# Comal County Environmental Health OSSF Inspection Sheet

## Permit of Authorization to Construct an On-Site Sewage Facility Permit Valid For One Year From Date Issued

Permit Number: 117363  
Issued This Date: 05/01/2024  
This permit is hereby given to: Alejandra Lopez Toledo Gonzalez

30251 LEROY SCHEEL RD  
BULVERDE, TX 78163

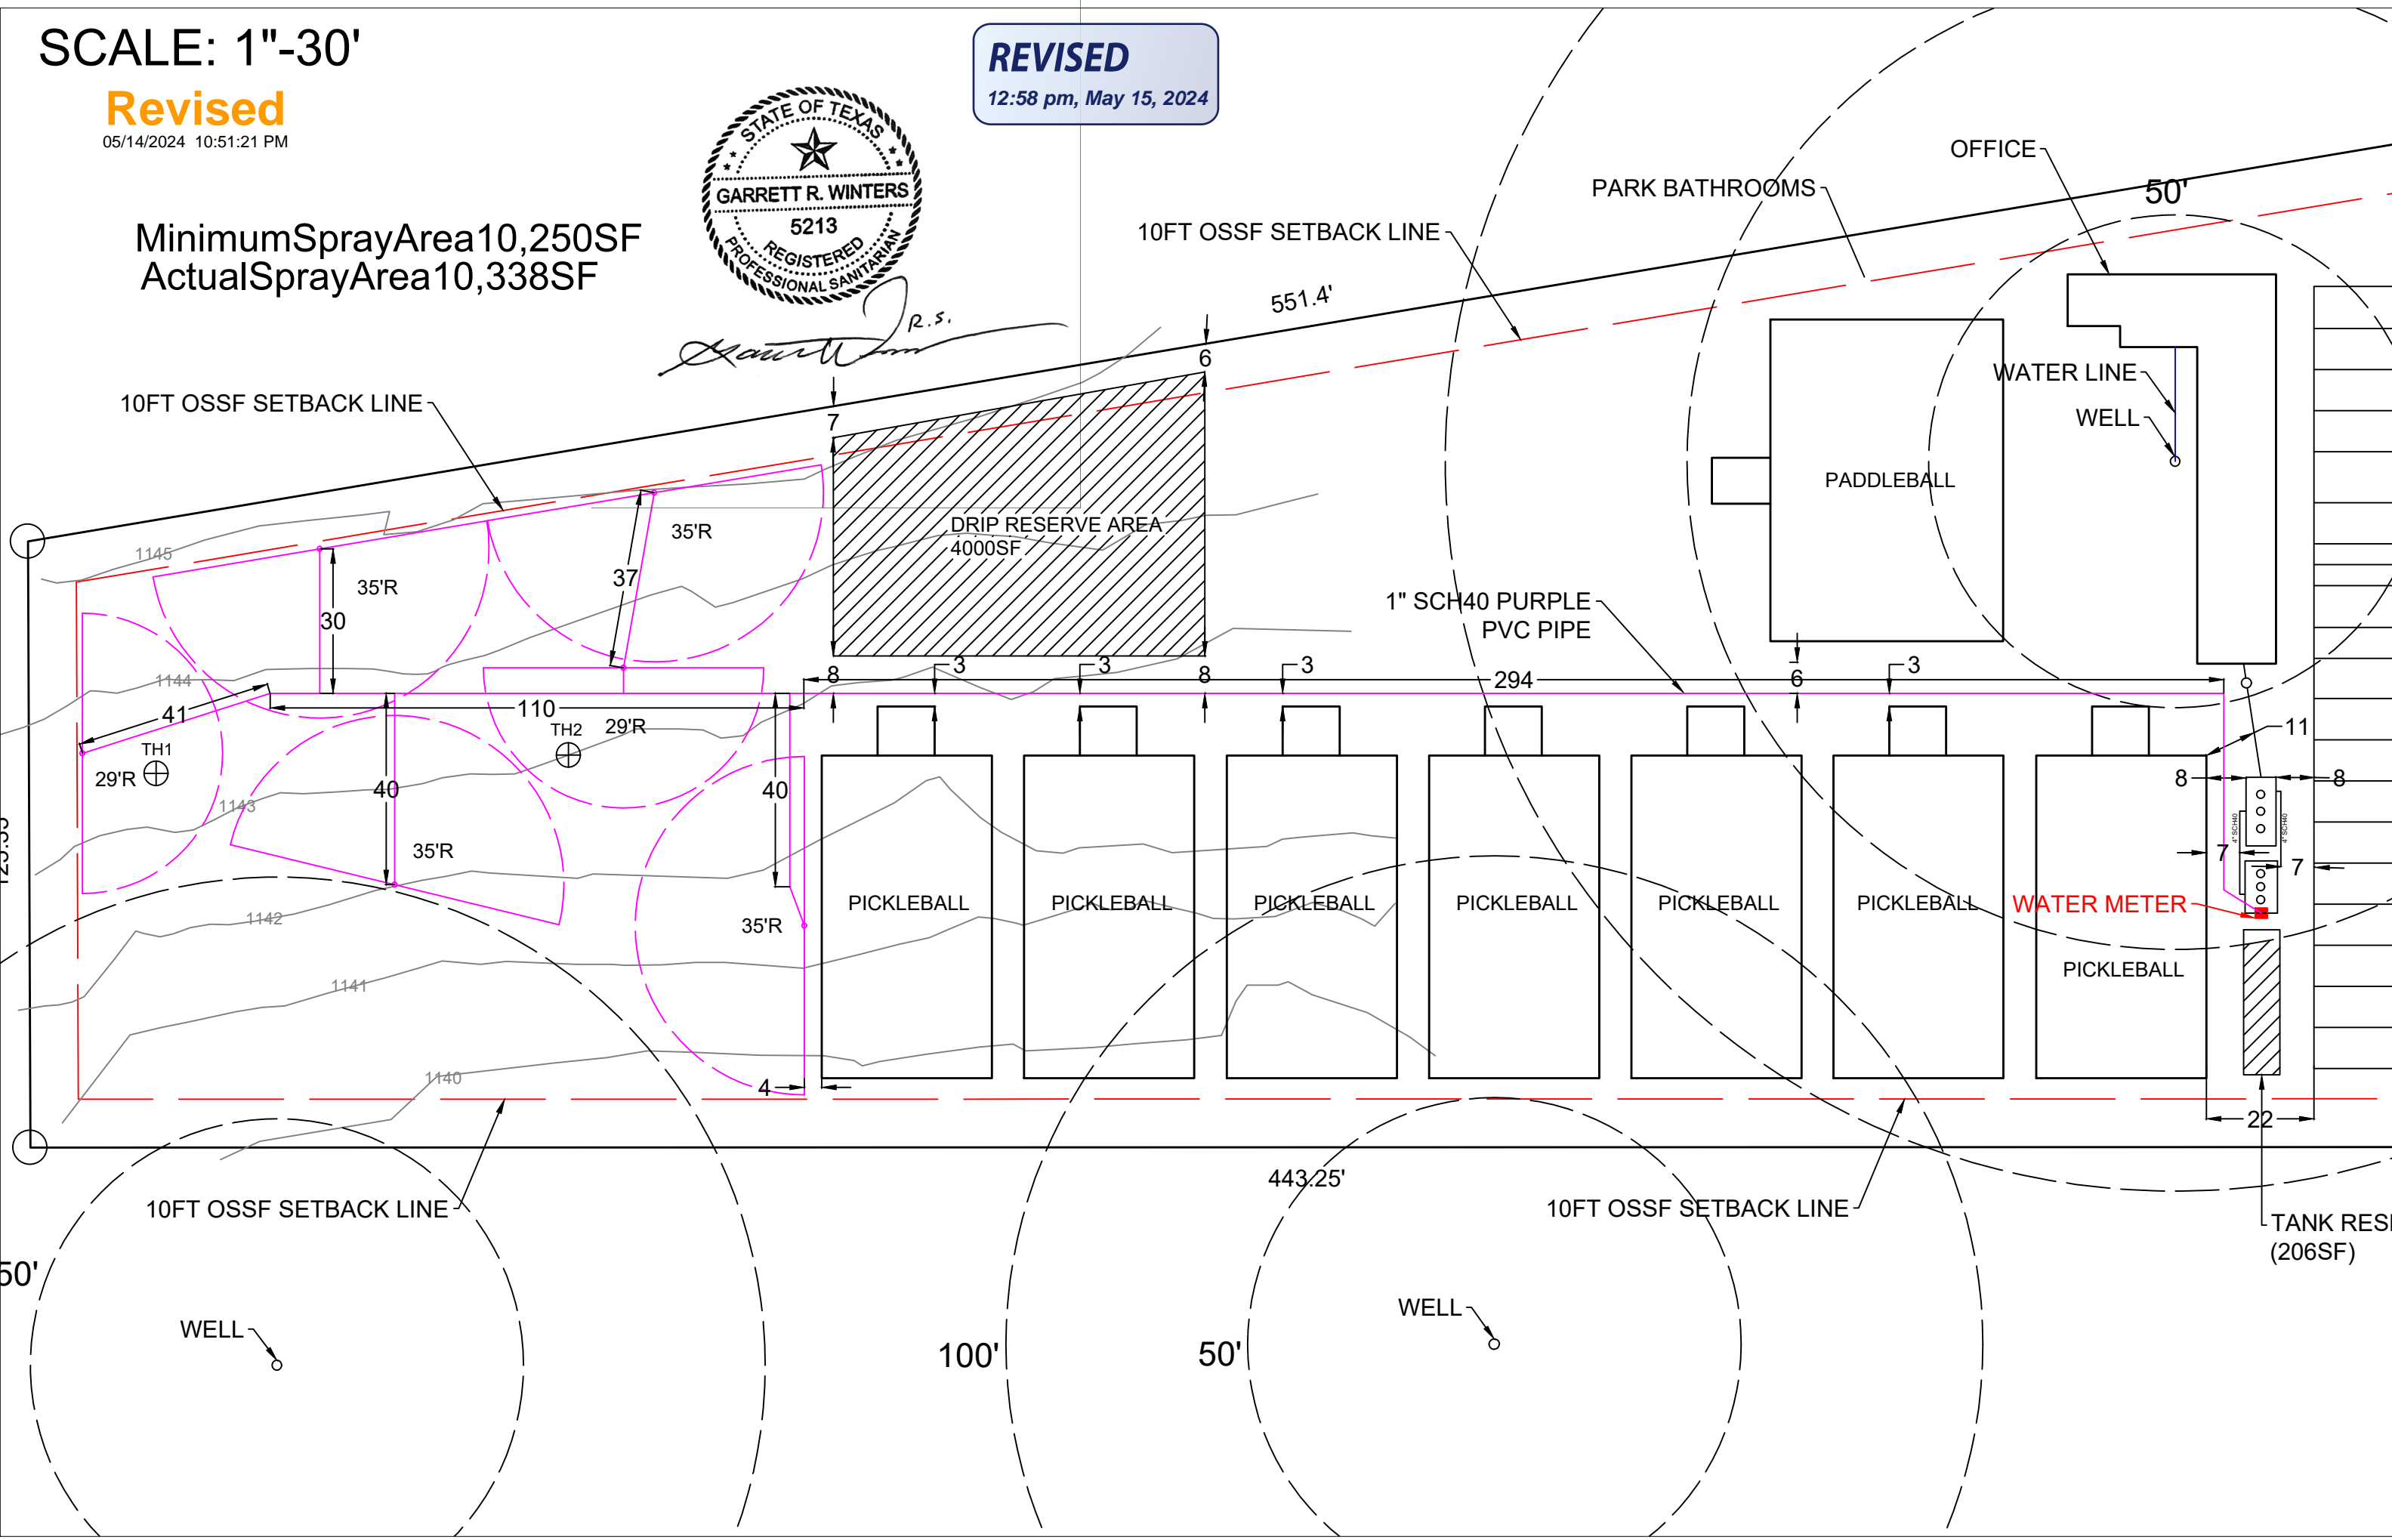
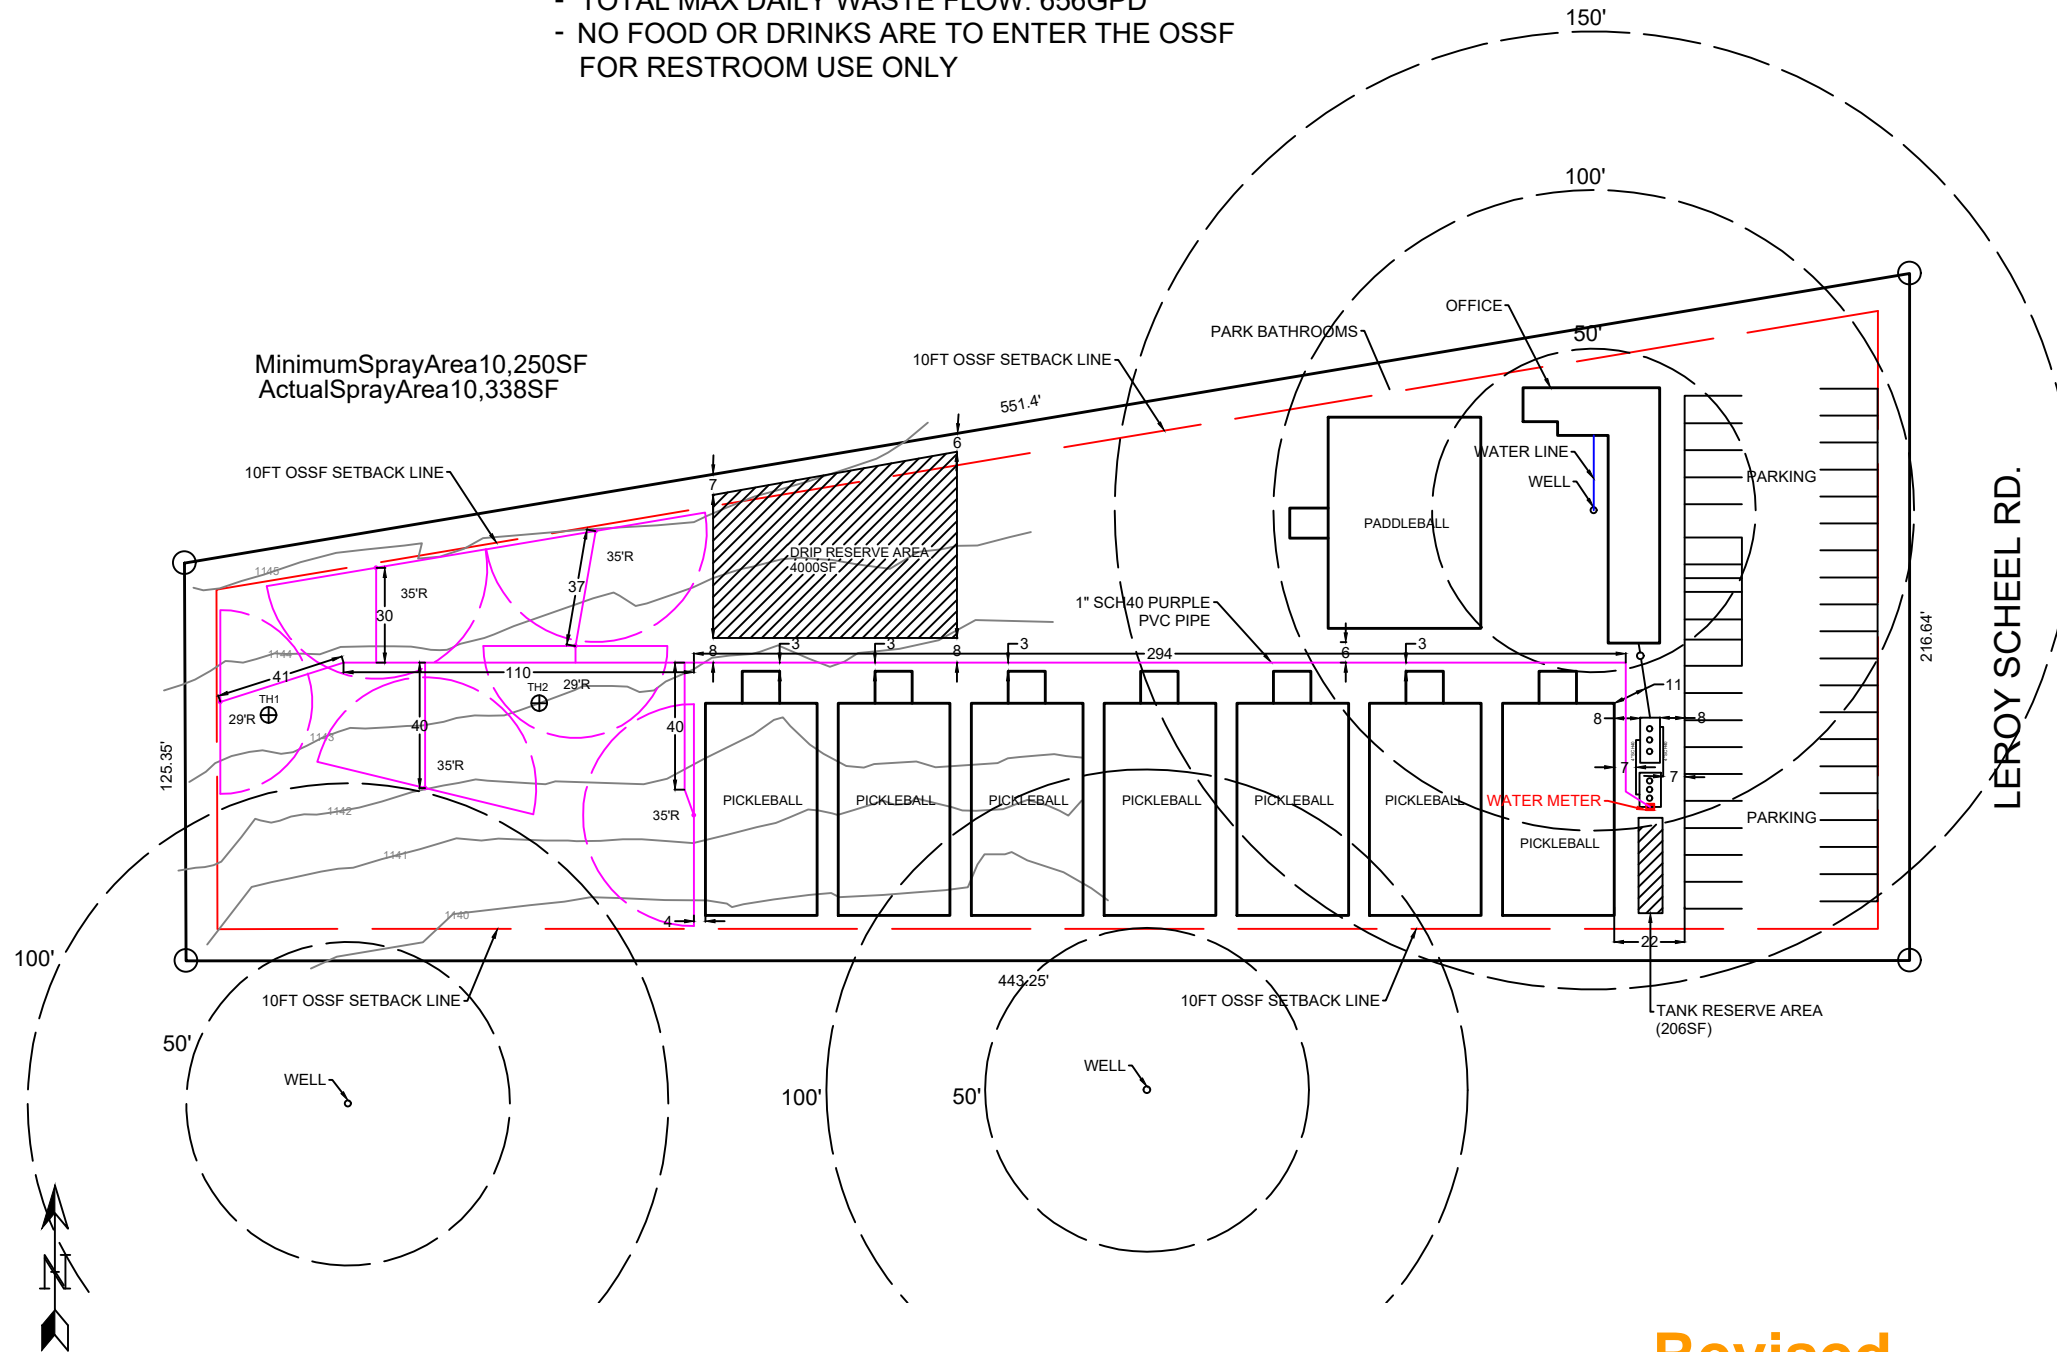
- Sprinkler Layout Change
- Parking lot Reduced
- Neighboring WELL Added to Site Plan

DATE	DESCRIPTION	REV#
5/8	NEIGHBORING WELL ADDED	2
	WELLS ADDED	
	SPRINKLER LAYOUT
